# UNITED STATES PATENT AND TRADEMARK OFFICE

APPLICATION NO.	FILING DATE	FIRST NAMED INVENTOR	ATTORNEY DOCKET NO.	CONFIRMATION NO.
09/627,637	07/28/2000	Kenichi Oinoue	P/3541-6	2855

**Office Action Summary**

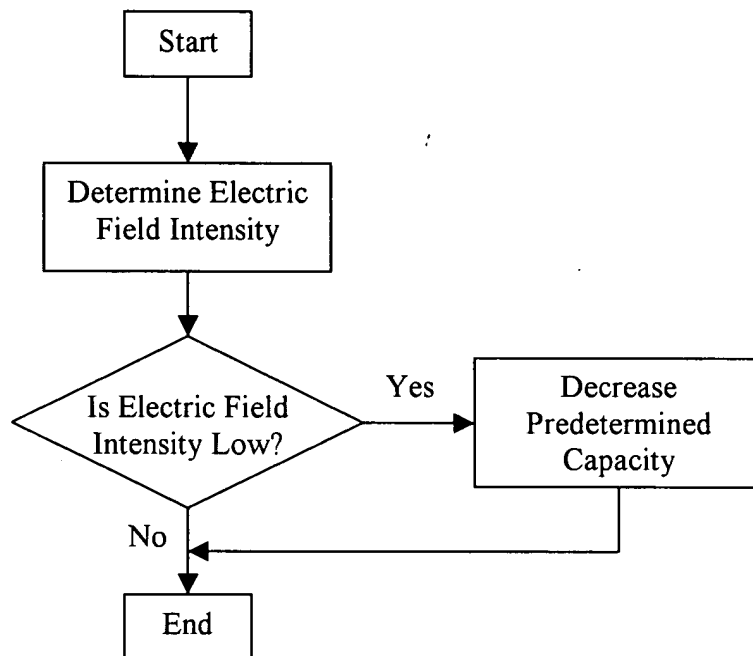
Claims 9, 10, and 17-20 are rejected under 35 U.S.C. 112, first paragraph, because the specification, while being enabling for decreasing the set memory capacity when it is judged that the electric field intensity is low, does not reasonably provide enablement for decreasing the set memory capacity when it is judged that it is impossible to transmit the recorded information. The specification does not enable any person skilled in the art to which it pertains, or with which it is most nearly connected, to make and use the invention commensurate in scope with these claims.

In order to overcome this rejection the Examiner suggests amending claim 9 to read “said transmission control means includes judgment means to judge the capability of transmitting the recorded information to a nearest communication base station, and said setting means decreases the set memory capacity when said judgment means judges that there is a low capability to

transmit the recorded information.” Examiner suggests similar amendments to claims 10 and 17-20.

Should Applicant adopt Examiner’s suggestions with regards to the claims, the Examiner further suggests that the Applicant add a further figure so as to show the limitations above. The Examiner suggests submitting a flow chart similar to the one illustrated bellow.
